U.S. DEPARTMENT OF VETERANS AFFAIRS

REQUEST FOR INFORMATION

SOLICITATION NO. VA245-17-R-0149

AMBULATORY CARE / PHYSICAL SECURITY IMPROVEMENTS, PROJECT 540-325

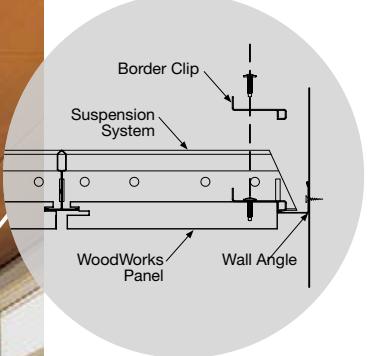
The Reflected Ceiling Plan (A9-2) indicates a New Wood – Look Ceiling in sections of 1301 and 1303. The finish schedule indicates AT-2 and AT-3 in those areas with a note to refer to the reflected ceiling plan. What material is required?

A/E Firm Response: Please see attached specification.
